Application for Works Approval

Works Approval Number	W6859/2023/1
Applicant	Pilgangoora Operations Pty Ltd
ACN	616 560 395
File number	DER2023/000562
Premises	Pilgangoora Operations Mining tenements M45/1260 and M45/1230 MARBLE BAR WA 6760 As defined by the premises maps attached to the issued works approval
Date of report	19/03/2024
Decision	Works approval granted

Figure 4: TSF3 underdrainage system

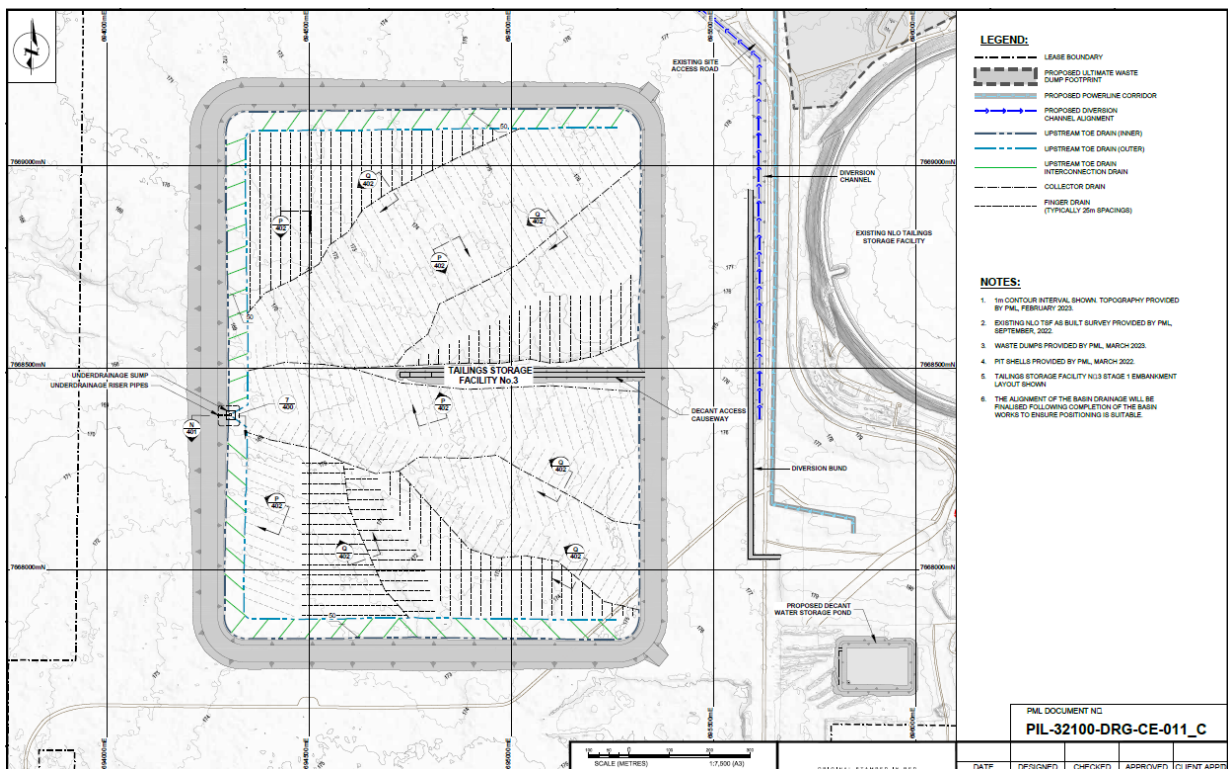
The works approval application documents indicate that seepage from TSF3 would be managed using the following drainage systems:

- 1) An underdrainage system comprising a network of finger drains spaced at 25 m intervals across the base of the facility which drain to a common water recovery sump;
- 2) A shallow (approximately 1.5 m deep) toe-drain around the margin of the facility; and
- 3) Diversion drains to divert surface water runoff around the ephemeral creek on which part of the facility is located.

The department considers that such a drainage system should be effective in minimising the seepage rate from TSF3. Based on research that has been undertaken by Araújo *et al.* (2018), the 25 m spacing of finger drains beneath the TSF3 should be adequate for capturing seepage from the facility. However, this is provided that they continue to work effectively, and do not progressively become clogged with silt or ferruginous bacterial precipitates over time. If this were to occur, the seepage rate through the base of the facility would increase, as would the rate of groundwater mounding near TSF3. Therefore, the department considers it necessary that the seepage rate from the facility is measured on an ongoing basis during its operational life using the methods described above.

Condition 2

- construction requirements relating to embankments (including liners), seepage recovery systems, decant tower, positioning of spigots and installing monitoring equipment (piezometers and settlement pins)

Figure 9: Electrical conductivity at 10 m depth

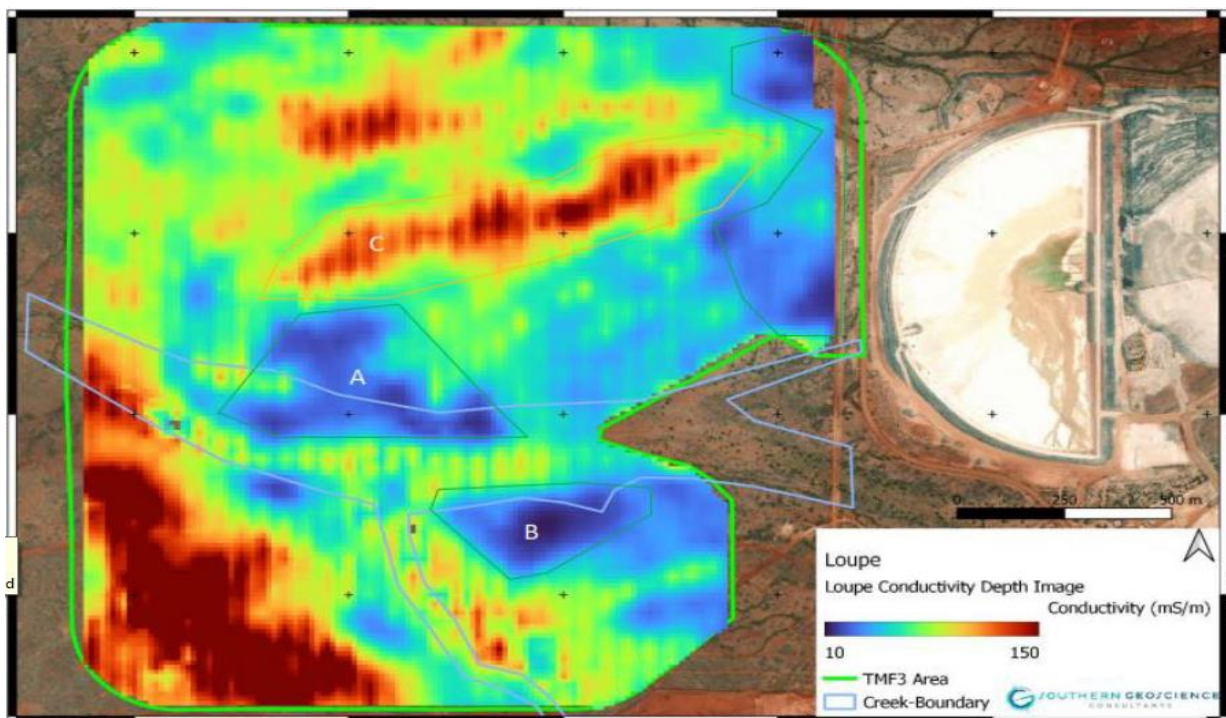
Seepage from stored tailings is expected through the basin floor so the applicant commissioned an electrical conductivity survey to be undertaken in 2022 (see Figure 9 below). Based upon the results of the survey, the applicant proposes the key pathways for seepage at TSF3 is expected to be primarily through the most permeable sand and gravel layers associated with the underlying creek systems, with the main flow paths away from the facility in a westerly direction towards the larger creek systems.

The groundwater beneath the proposed location of TSF3 sits within a weathered fractured bedrock aquifer comprising granite and greenstone. The westerly trending creeklines likely feature a greater depth of weathering into the underlying bedrock and therefore could act as preferential pathways for groundwater flow although previous field investigations have found relatively low permeability in the bedrock.
